Item 2
5 Aeolus Street, Ryde - APL2023/0001 - S8.3 Review of determination of LDA2021/0445
Proposal: Demolition of structures and construction of a childcare centre.
Report prepared by: Senior Coordinator - Development Assessment

**City of Ryde
Local Planning Panel Report**

DA Number	APL2023/0001
Site Address & Ward	5 Aeolus Street, Ryde Lot 10 DP 7159 - Central Ward
Zoning	R2 Low Density Residential
Proposal	Demolition of structures and child care centre
Property Owners	Mr N Navasardian and Mrs S Navasardian
Applicant	Mr Nigel White, Planning Direction P/L
Report Author	Holly Charalambous, Senior Coordinator Development Assessment
Lodgement Date	21 March 2023
No. of Submissions	10 objecting to the development (8 unique) 12 in support of the development
Cost of Works	\$2,470,050.00
Reason for Referral to Local Planning Panel	Section 8.5 of the Environmental Planning and Assessment Act 1979: Development Application was determined by the Local Planning Panel.
Recommendation	Confirmation of Refusal
Attachments	1. Proposed amended plans 2. Plan of Management 3. SEPP Table of Compliance 4. DCP Table of Compliance 5. RLPP Determination & Statement of Reasons 6. Assessment Report for LD

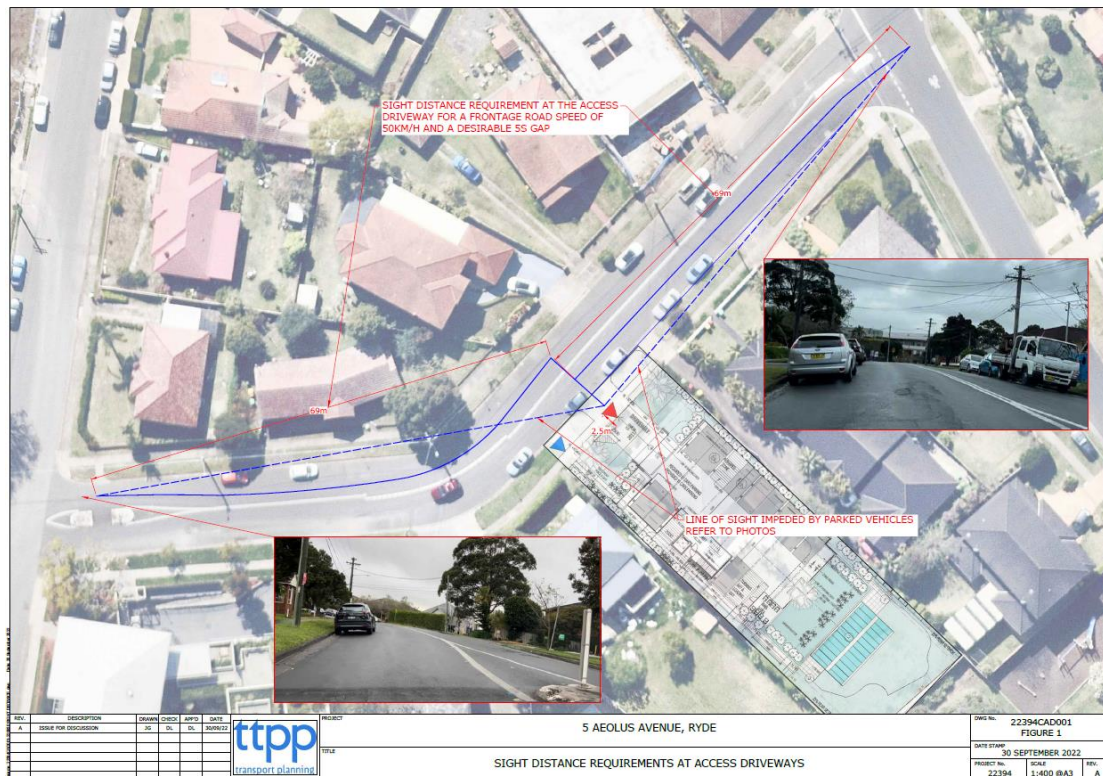
4. Sight distance is impeded by parked vehicles on both sides of Aeolus Avenue as shown in **Figure 21** below. As a result, the egress movement would be unsafe due to the restrained sight distance caused by the parked vehicles on both sides of the driveway.

Figure 27: Extract from the Shadow Diagrams 21 June showing the extent of overshadowing generated by the proposed development onto No. 3A Aeolus Avenue.

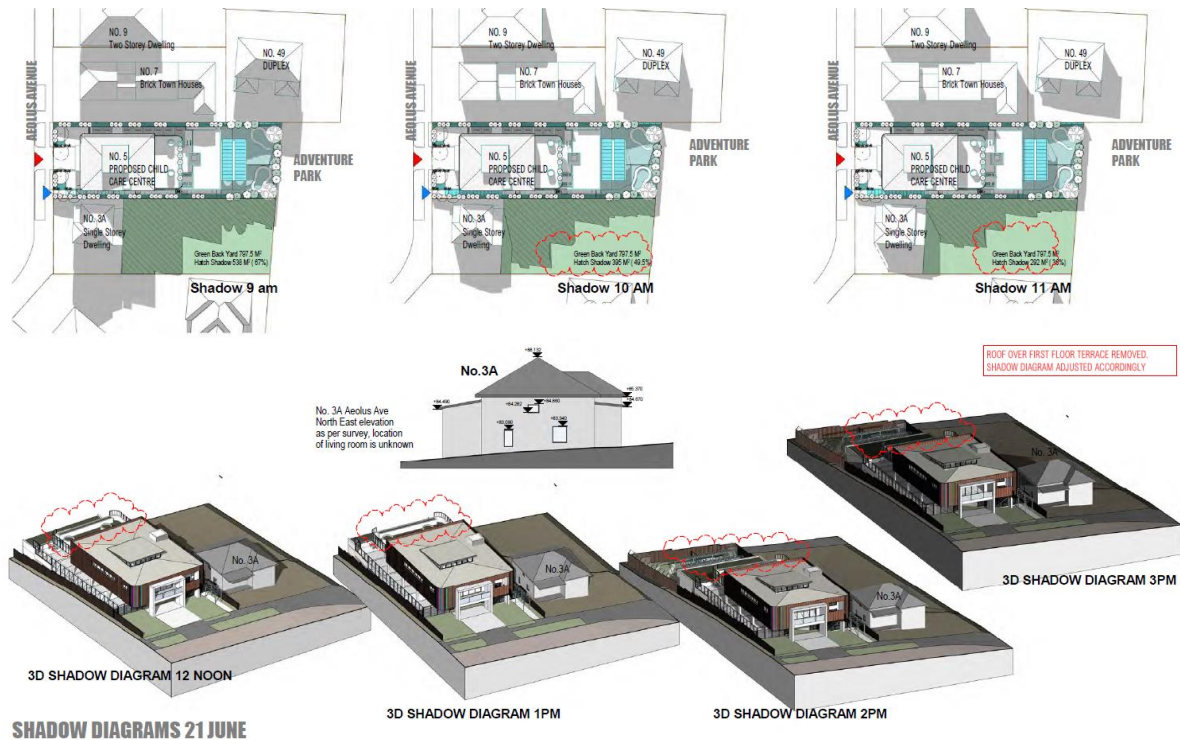
In mid-winter, the dwelling at No. 3A and its rear private open space area is overshadowed in the morning period until approximately 1pm. The overshadowing of the dwelling is clear from 2pm onwards. The rear private open space of No. 3A continues to experience some overshadowing in the afternoon period. This is shown in **Figure 27** below. These plans reflect the change in levels on both sites and are a suitable representation of the impact of the development. The applicant has demonstrated that No. 3A continues to benefit from sufficient access to sunlight in line with the development controls in the Ryde DCP 2014, as discussed at **Attachment 3**.

SECTION A - A

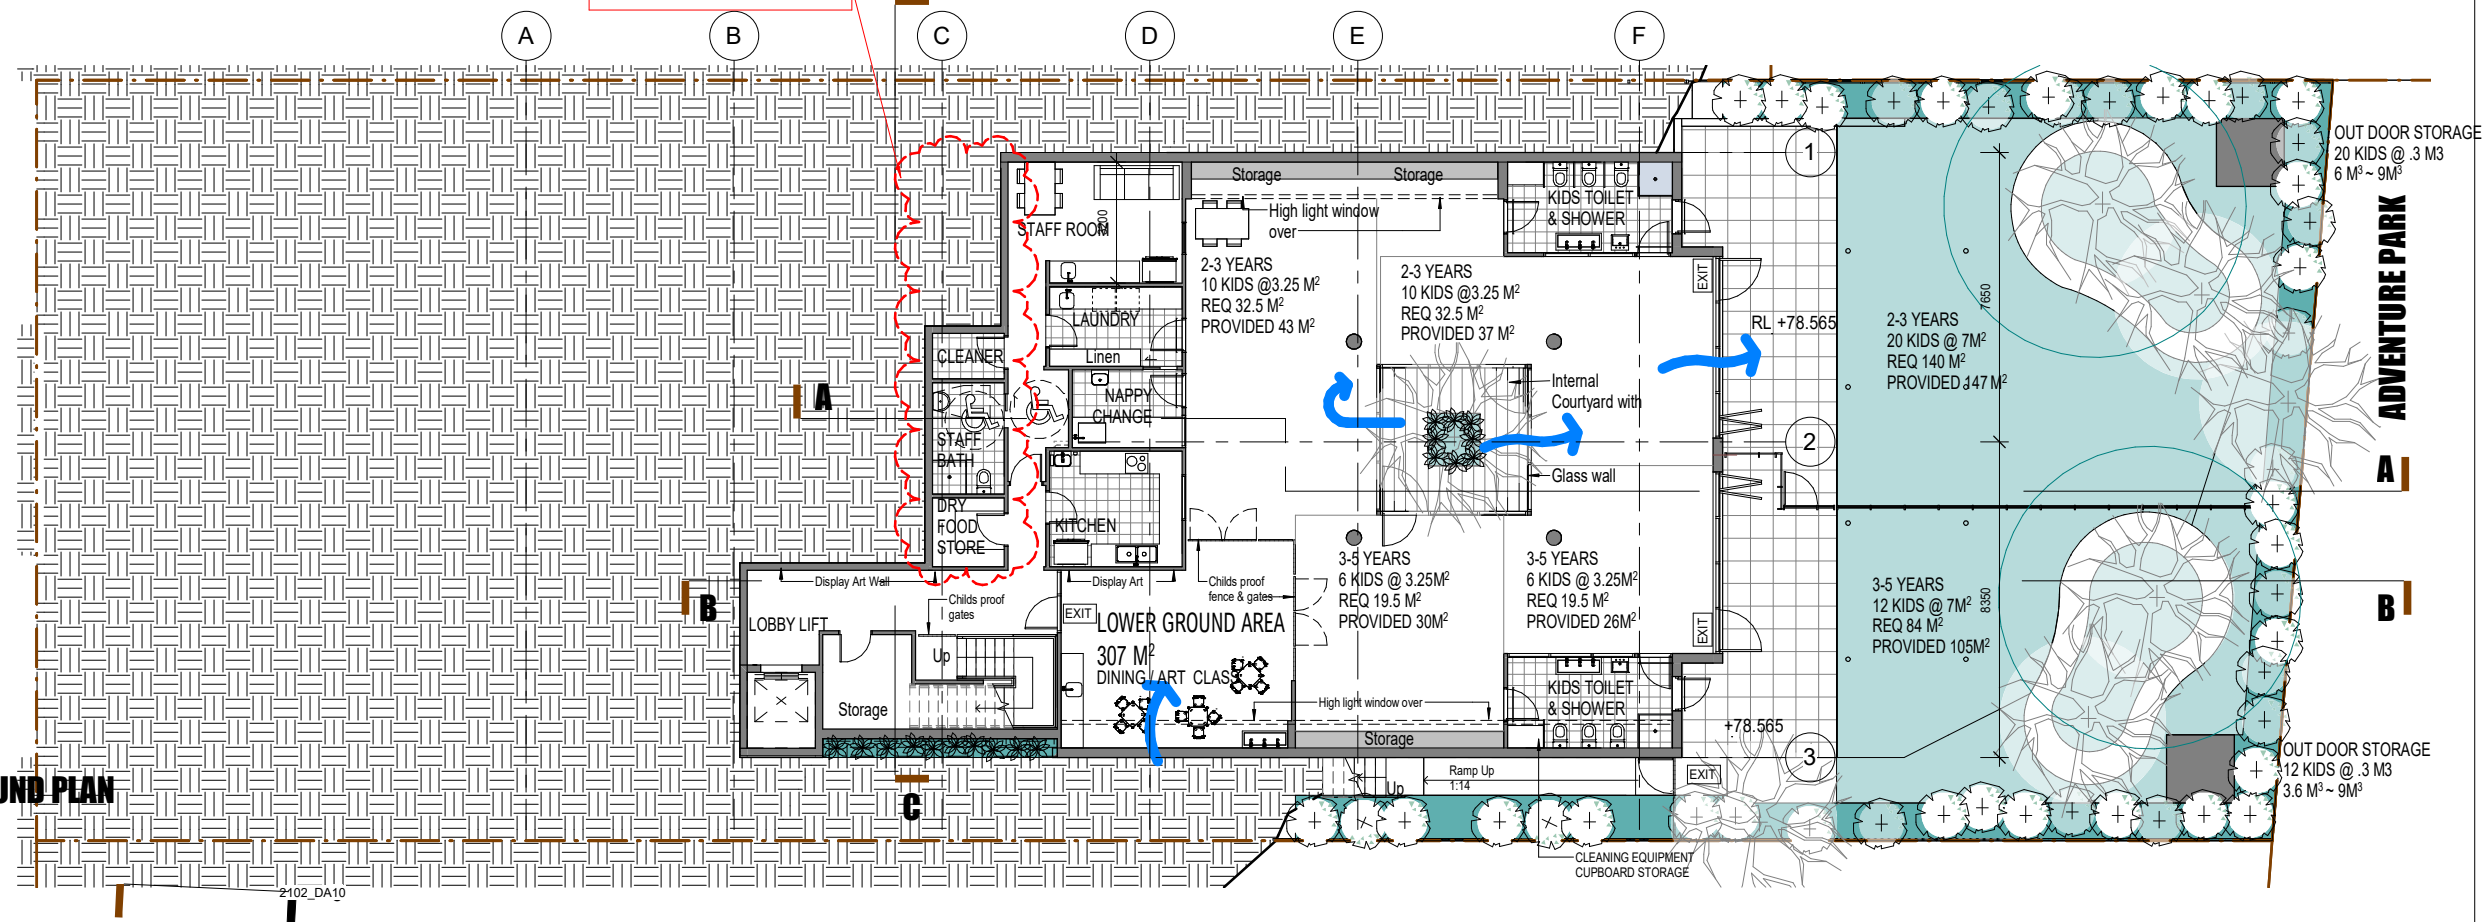
FOOT PRINT REDUCED
TO AVOID FLOOR OVERLAP

SHADOW DIAGRAMS 21 JUNE

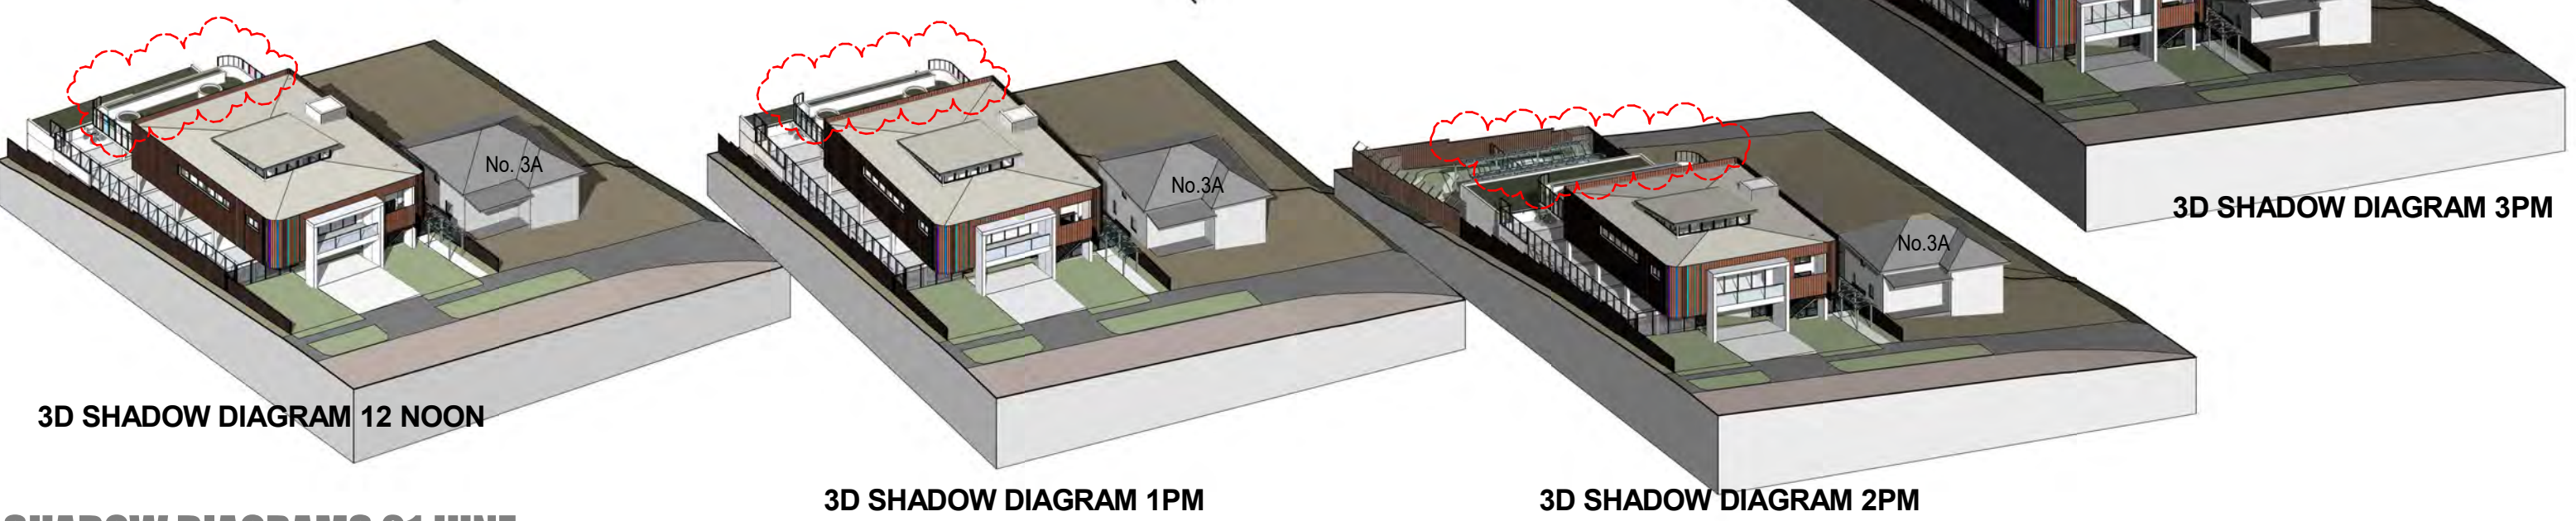
ROOF OVER FIRST FLOOR TERRACE REMOVED.
SHADOW DIAGRAM ADJUSTED ACCORDINGLY

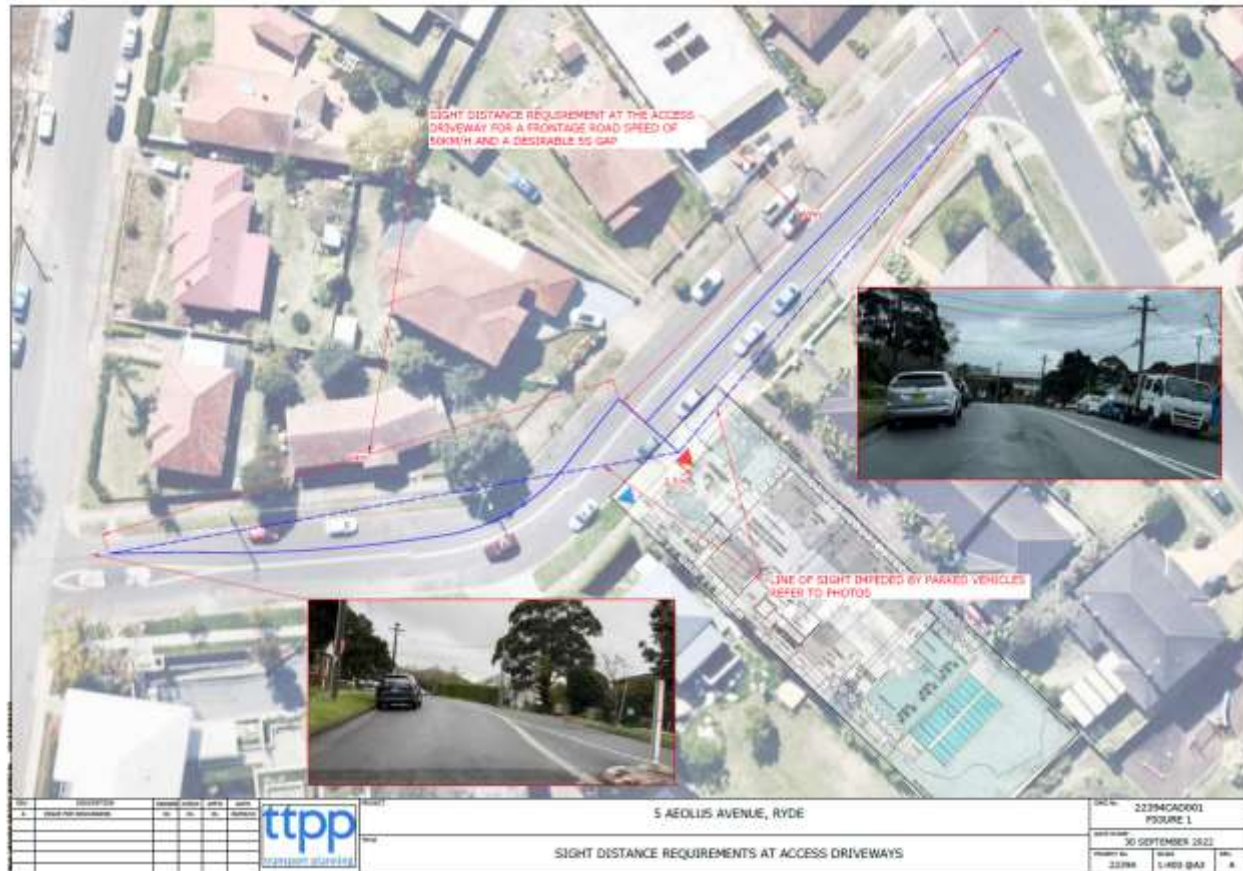
4. Sight distance is impeded by parked vehicles on both sides of Aeolus Avenue as shown in **Figure 22** below. As a result, the egress movement would be unsafe due to the restrained sight distance caused by the parked vehicles on both sides of the driveway.

Figure 27: Extract from the Shadow Diagrams 21 June showing the extent of overshadowing generated by the proposed development onto No. 3A Aeolus Avenue.

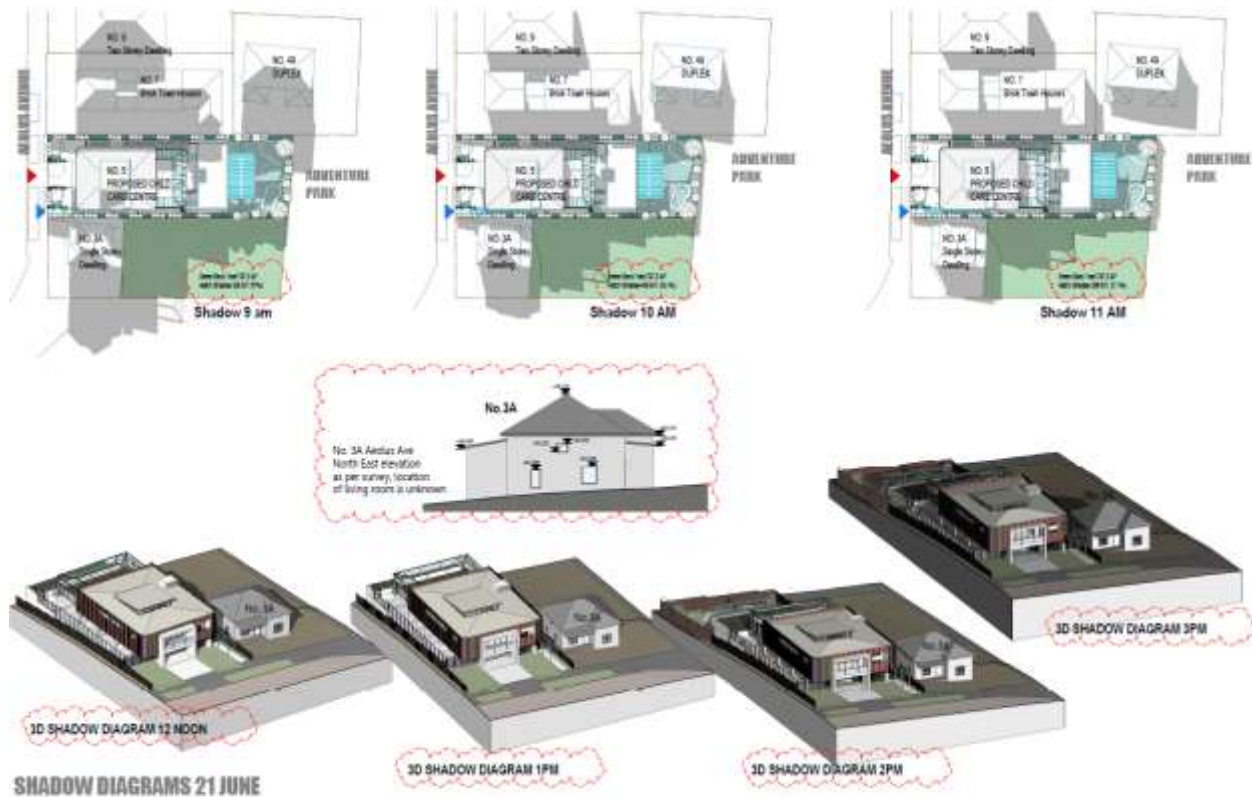
In mid-winter, the dwelling at No. 3A and its rear private open space area is overshadowed in the morning period until approximately 1pm. The overshadowing of the dwelling is clear from 2pm onwards. The rear private open space of No. 3A continues to experience some overshadowing in the afternoon period. This is shown in **Figure 27** below. The applicant has demonstrated that No. 3A continues to benefit from sufficient access to sunlight in line with the development controls in the Ryde DCP 2014, as discussed at **Attachment 3**.

Figure 1: 5.2 Long Parking Spaces

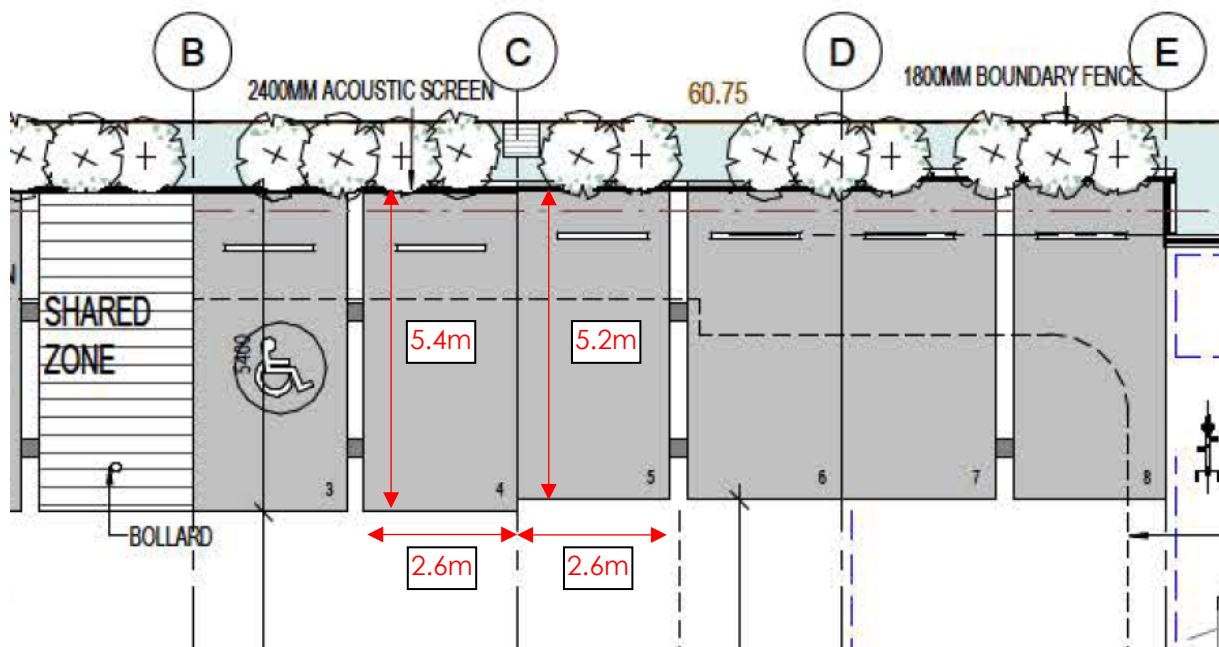
The latest car park design provides 11 parking spaces, although it is not clear which are staff and which are drop off spaces. While most parking spaces are designed to provide compliant dimensions of 5.4m x 2.6m (noting that the staff spaces could be reduced to a 2.4m width), Bays 5 to 8 appear to provide a length of 5.2m which is limited to the rear by a 2.4m high acoustic screen, thus the parking spaces cannot overhang into the landscaped area.

Figure 7: Sight Distance Assessment

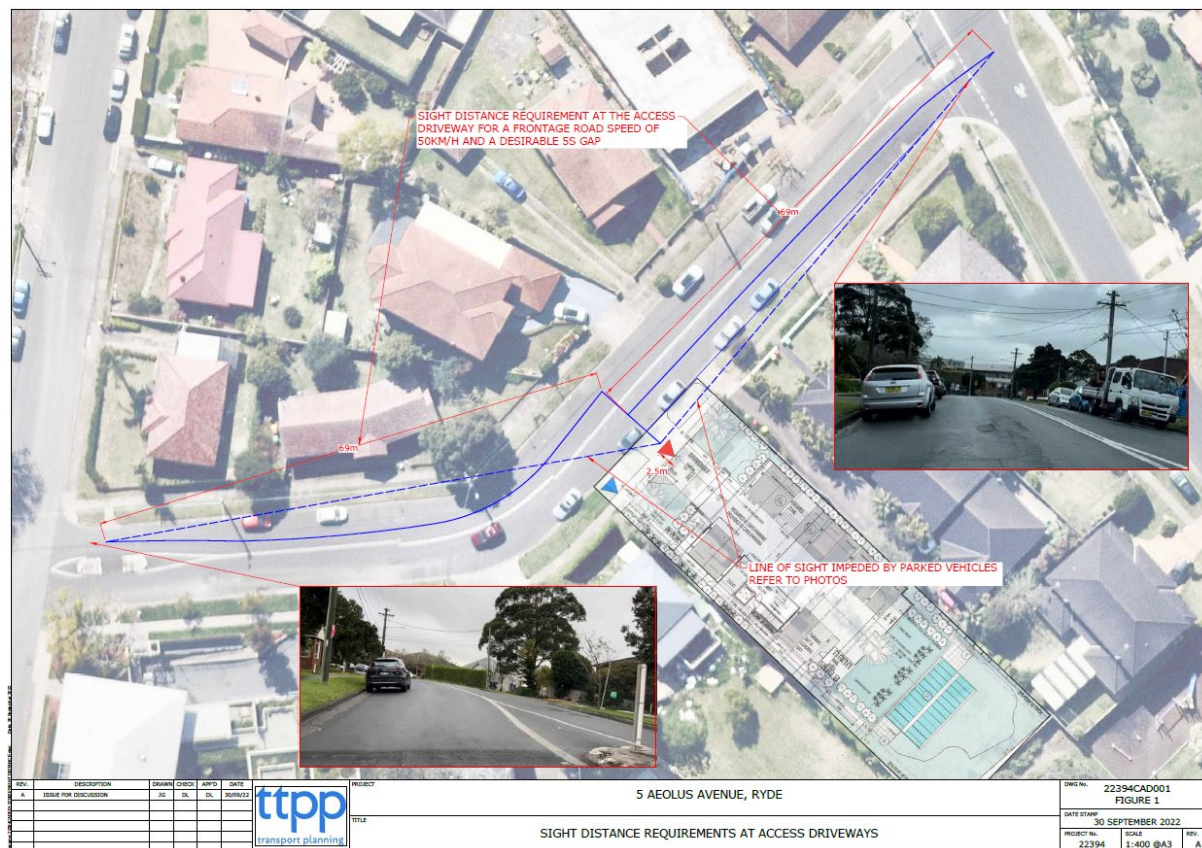
TTPP has undertaken a sight distance assessment as shown in Figure 7 which indicates that the sight distance is impeded by parked vehicles on both sides of Aeolus Avenue. An enlargement of the sight distance assessment is shown in Attachment One.
